Comments on the report "Indications of anomalous heat energy production in a reactor device containing hydrogen loaded nickel powder." by G.Levi, E.Foschi, T.Hartman, B.Höistad, R.Pettersson, L.Tegnér, H.Essén.

Göran Ericsson^{*}, Stephan Pomp
Division of applied nuclear physics, Uppsala University, Sweden

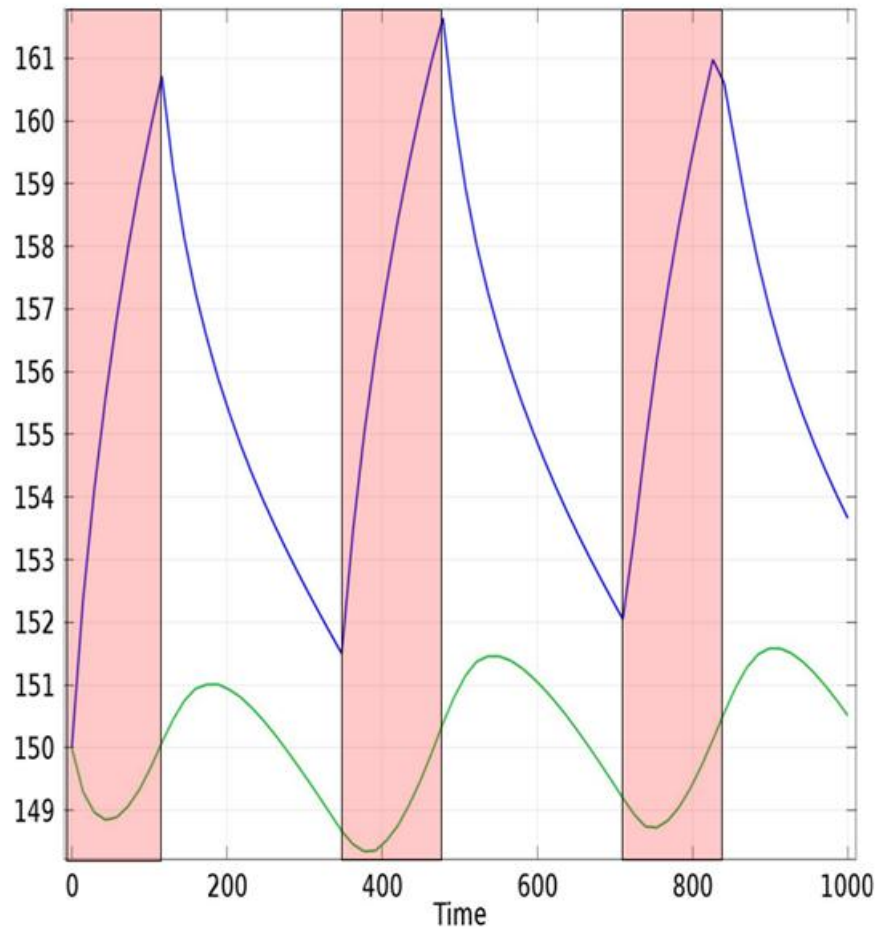
The authors present a long discussion on the deviation of the time-dependence of the observed temperature/emitted power from that of a generic resistor (pgs 25-26). They further argue that this time-evolution is supporting evidence for the presence of an anomalous heat source in the E-Cat device. We do not find this discussion convincing.

- We have performed a thermal analysis using the physics simulation tool “COMSOL” for MatLab, using values for geometry, materials and electrical heating coils extracted from the report (March test, cylindrical part only[†]). In Fig. 1 we show results from a calculation including resistive heating only (810W for 2min, then 0W for 4 min). The shape of the temperature curve at the surface is quite similar to what is presented in Ref. 1, Plot 3. Since

we have not included any anomalous heat source in our model, it seems clear that the observed shape of the temperature at the surface can simply be attributed to heat diffusion from the internal heat source(s) through the steel cylinder to the surface. As a matter of fact, there seems to be no reason whatsoever why the surface temperature curves should look anything like those of a generic resistor (as, e.g., claimed in the caption of Plot 3 on page 25 in Ref. [1]), when this resistor is buried deep within the device.

- Our modeling indicates that the observed time-dependence is perfectly consistent with a situation where the internal heat source is supplied purely by resistive heating. Thus, the argument that the *shape* of the temperature/power curves is an indication of an anomalous internal heat source is not correct. And even if this has no direct bearing on the existence (or not) of any anomalous heat source within the reactor, the lack of understanding of such a fundamental physical process does not inspire confidence in the presented results.

- From our thermal analysis it is also clear that if any form of pulsed, internal (electrical plus possibly "anomalous") power is supplied, the temperature (and hence the emitted power) at the surface of the reactor by necessity has to be out of phase with the power contributed by the internal sources. And obviously, the displayed pattern of surface heating and cooling clearly indicates that the internal heat source is not constant. However, the curves presented in [1] (especially Plot 8 on pg 27) show the electrical power and the surface emission power to be in phase. This can have two explanations. The simplest one is that the two curves have been forced "synchronized" for the sake of illustration by the authors. This should then have been clearly pointed out in the report, but, and this is more serious, it would then also constitute a deviation from reporting the actual experimental data as well as withholding important information that could contribute to an understanding of the device and its internal processes. The second possibility could be that the phase and amplitude of the additional anomalous heat source is such as to precisely synch the two curves. We leave it open if such a scenario can even be conceived, but it would of course be a rather remarkable coincidence, and could actually offer an independent possibility to assess some of the properties of the alleged anomalous source. At present we have not had the resources to take our modeling to that level.
